HT812 Firmware Release Note

FIRMWARE VERSION 1.0.2.5

HT812

FIRMWARE VERSION 1.0.2.3

PASSWORD CHANGE CONFIRMATION

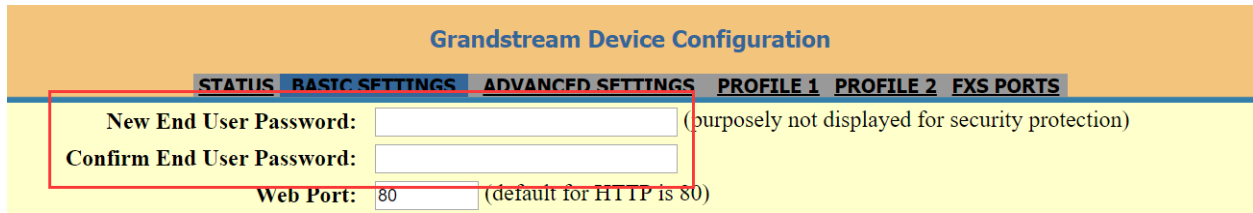
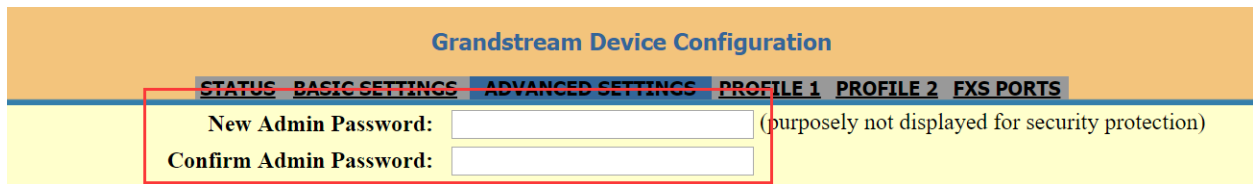
- Added network check mechanism to enable or disable WAN port web access. [WAN PORT WEB ACCESS]
- Added a re-enter box to confirm change user and admin password on web GUI to avoid typo or mistakes. [PASSWORD CHANGE CONFIRMATION]

Allow user to re-enter the password to confirm the password is input correctly.

User can find the re-enter confirm box at Web ->Basic Settings/Advanced Settings
